Subject: **UMT0102261/CU-521**
Wildwood Club Proposed Dike between structures 103A7478 & 103A7477

RE: Wildwood Club Proposed Dike between Structures 103A7478 & 103A7477

**Project No: UMT0102261
CU-521**

Wildwood Club-Pictures of Proposed Project Site

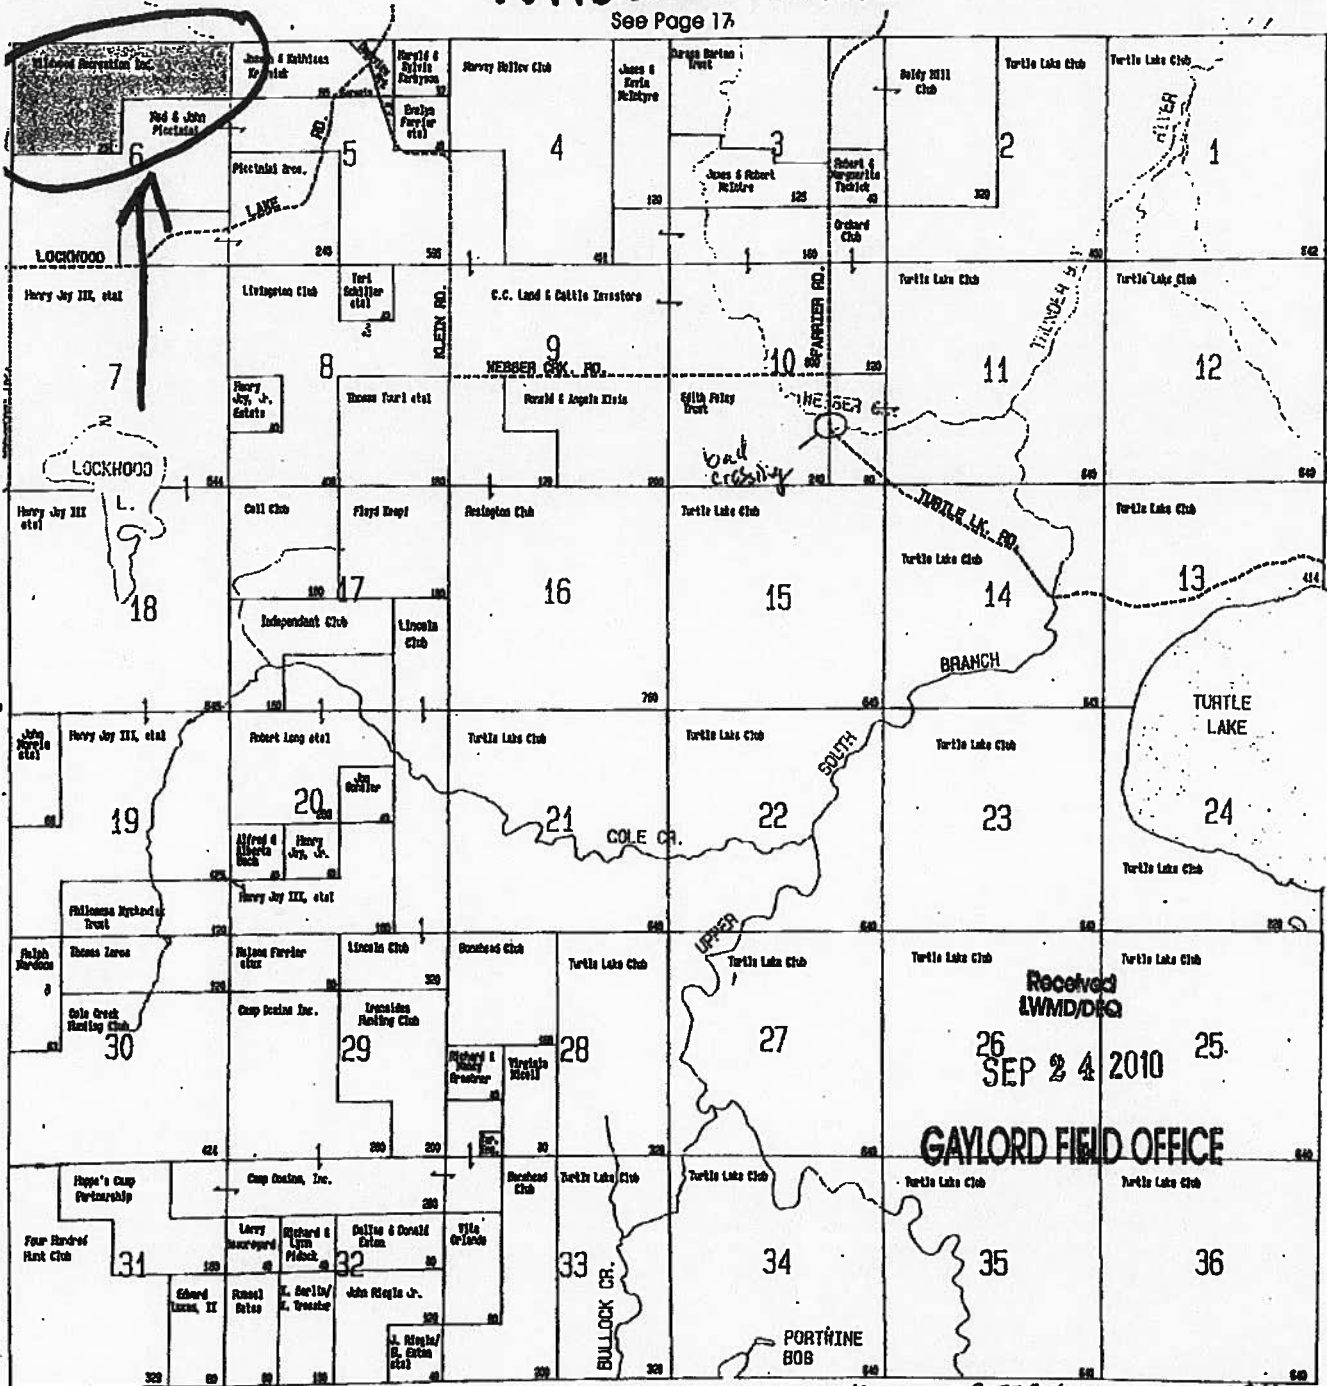
Earthen dike will be constructed on current crossing. Water "flow" is to the left (NW).

Picture taken from low point of proposed construction site. No bed or banks exist on this drainage, and a handful of sedges (less than 12) are the only wetland plants on-site.

PROFILE- DIKE #1

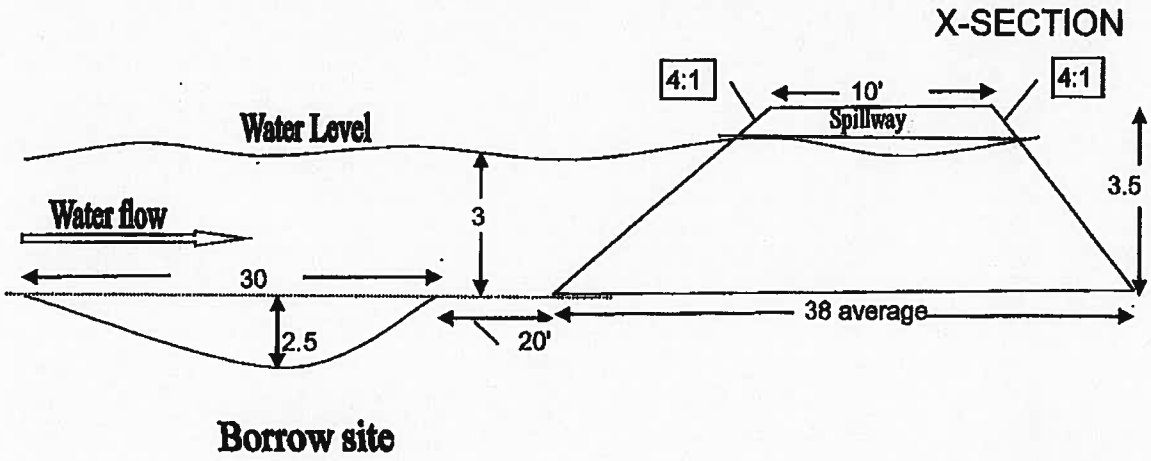
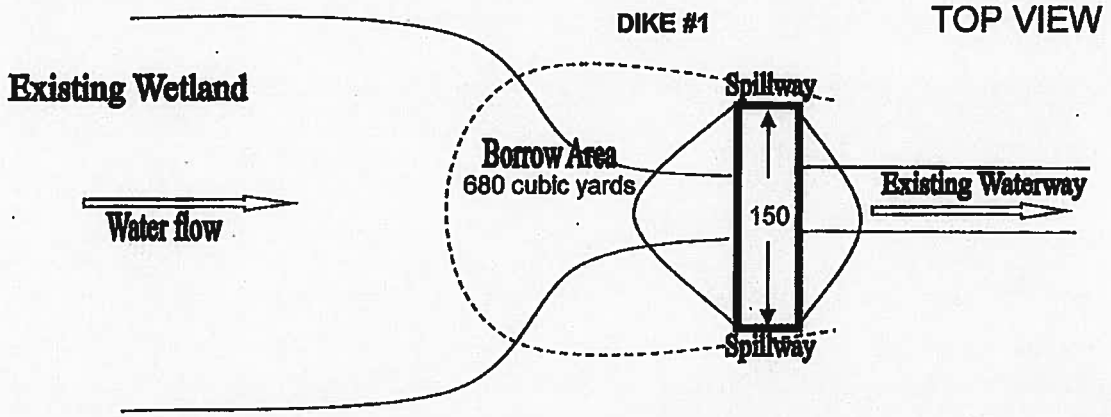
1. The top of the dike be no less than 14' in width to accommodate vehicular traffic.
2. ITC will not be responsible for any damage to the dike caused by ITC personnel or contractors accessing, maintaining or replacing the transmission poles or conductors.

The USFWS is happy to comply with the request to widen the top of the dike proposed for construction at the Wildwood Club property to 14 feet wide. We will acquire a revised permit from the State of Michigan once permission is granted from all entities, and we are ready to begin the construction phase of the project.
